**DECLARATION OF JEFFREY BLEASE IN SUPPORT OF THE JV'S MOTION TO COMPEL
PRODUCTION OF DOCUMENTS**

COMPOSITE EXHIBIT A

Subject: [External] RE: RE: Washington Bridge repair design

1. Design calcs 11 & 12 Anchor Plate and Anchor Bolt

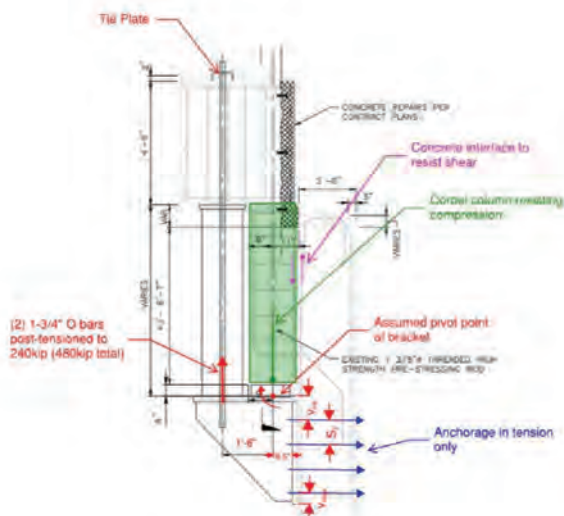
The calculation assumes the pivot point of the bracket is at the centerline of the existing PT anchorage which results in a moment arm of 1'-6" to the new PT rods. Wouldn't it be a more conservative design to assume the pivot point is at the interface of the new steel corbel and the concrete pier? This location would seem to make more sense for locations where the existing PT is no longer in-tact.

2. The drawings do not indicate the size of the anchor rods connecting the steel bracket to the concrete pier.
3. The drawings do not indicate the size of the holes to be drilled through the concrete pier for the anchor rods.
 - a. After installation of the anchor rods, how will bearing of the bolts against the concrete be achieved such that shear transfer through the anchors occurs?
 Is some level of movement of the entire assembly assumed before contact is achieved?
4. Stressing of the new PT rods will induce a moment into the existing pier wall. Has the existing pier wall been checked for this new moment?
5. Regarding the 3/8" elastomeric bearing pad, has long-term compression of that pad been looked at which could lead to loss of some PT force over time?
